BADGER MOUNTAIN SOLAR AI	PPLICATION REVIEW - EFSEC COMMENTS TO	ORIGINAL APPLICATION
ltem	Section	Report	Торіс	Information Request	Applicant Response
DR-W-01	Water	N.A.	Describe the potential impacts of the Project on Stream ST-510 and	What Project features would impact streams?	As described in ASC Part 4, Section 4.3.B, the Applicant is designing the Project to avoid and minimize impacts to ephemeral streams to the extent feasible. Specific stream crossing locations are undetermined at this stage in Project design and, upon finalization, will be limited to ephemeral streams within the Project area, if needed. Per ASC Part 4, Section 4.3.C.1, the conceptual design shown on the Project's Preliminary Site Plan (ASC Attachment A, Figure A-1) includes the potential for ephemeral stream crossings or culverts to be installed over ephemeral drainages for Project components such as collector lines and road crossings, but as noted above, specific stream crossing locations are undetermined at this stage in Project design. While not anticipated, if bridge construction is necessary, the abutments would be placed outside of the ordinary high water mark unless no other feasible alternative placem

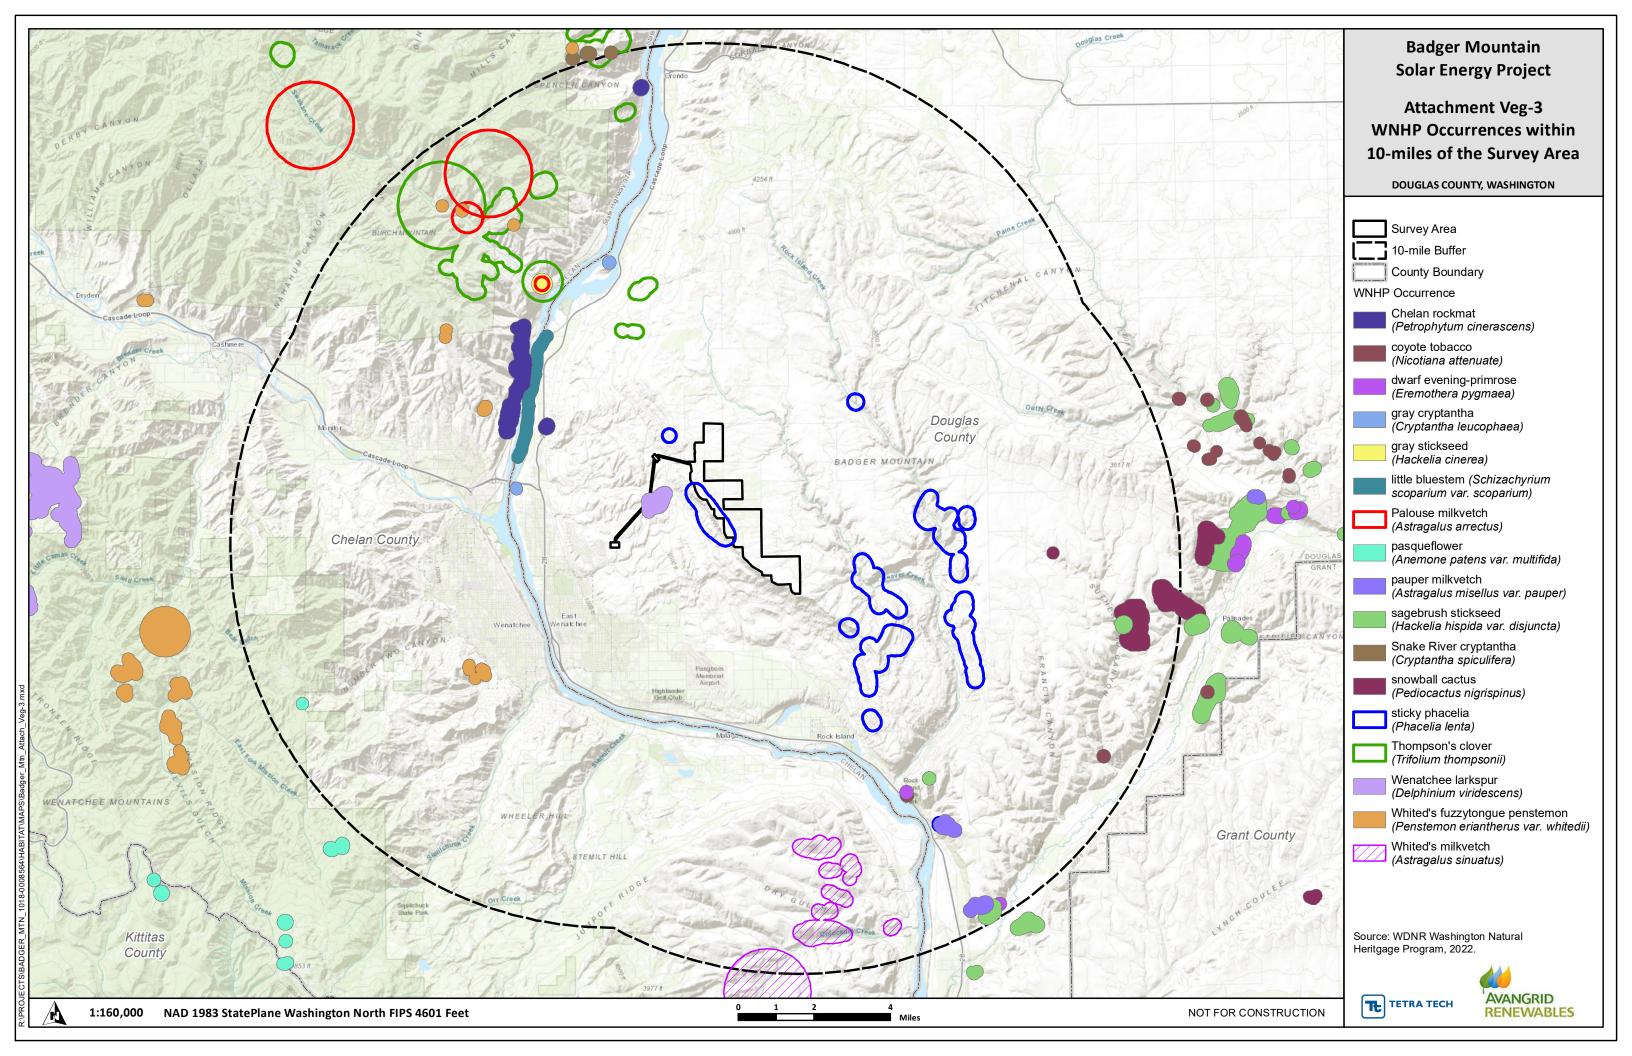
DR-WLF-02	Wildlife	Attachment G: 2021 Wildlife and Habitat Survey Report	Pg 4 describes the field methods.	Provide a map of meander transect locations.	An approximation of meander transect locations, based on GPS data collected during surveys and surveyor recall, is provided in <b>Attachment WLF-1</b> .
